Access Compliance Report

Public Rights-of-Way

(Curb Ramps)

Intersection ID: 46321	Main Street: MAGNASCO_LN	Cross Street: MANES_CT	Location:	N
ADA ID: 438F36C593C0	Ramp Type: PerpDiag	Initial Pass/Fail: Fail	Overall Compliance: No	Severity Score: 13.75

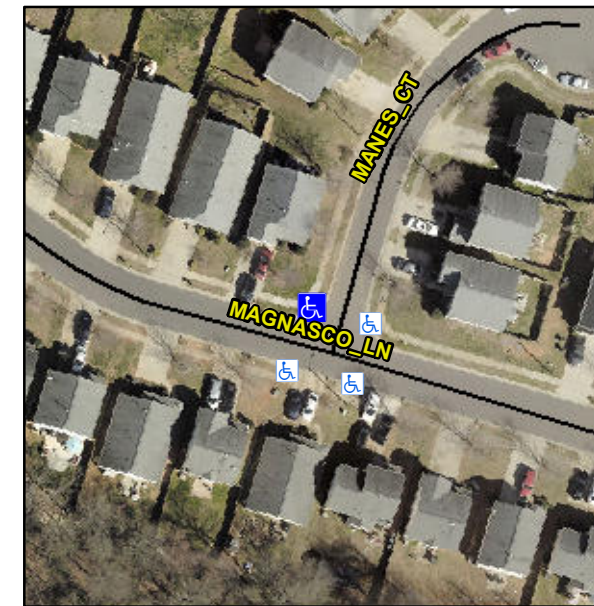
Not Found, R304.2.2, R304.5.3

Compliance	Description	Data	Compliance	Description	Data
N/A	Ramp Length (in)	54.0	No	Ramp Slope (%)	10.3
Yes	Ramp Width (in)	48.0	No	Ramp XSlope (%)	3.7
N/A	Flare Type LT	N/A	N/A	Flare Type RT	N/A
N/A	Flare Slope LT (%)	N/A	N/A	Flare Slope RT (%)	N/A
N/A	Flare Traversable LT?	N/A	N/A	Flare Traversable RT?	N/A
N/A	Landing Length (in)	N/A	N/A	DWS Provided?	N/A
N/A	Landing Width (in)	N/A	N/A	DWS Contrast?	N/A
N/A	Landing Slope (%)	N/A	N/A	DWS Length (in)	N/A
N/A	Landing X Slope (%)	N/A	N/A	DWS Full Width?	N/A
N/A	Landing Curb? (Y/N)	N/A	N/A	DWS Offset (in)	N/A
N/A	Shared Landing?	N/A			
N/A	Gutter Ponding?	N/A	N/A	Gutter Slope (%)	N/A
N/A	Gutter Lip Ht (in)	N/A	N/A	Gutter X Slope (%)	N/A
N/A	Painted X Walk1?	No	N/A	Painted X Walk2?	No
	X Walk 1 Direction	To SW		X Walk 2 Direction	To SE
N/A	X Walk 1 Width (in)	N/A	N/A	X Walk 2 Width (in)	N/A
	X Walk 1 Slope (%)	4.0		X Walk 2 Slope (%)	2.6
	X Walk 1 X Slope (%)	5.3		X Walk 2 X Slope (%)	1.2

Remove & Replace Curb Ramp With Two New Directional Ramps or Equivalent.
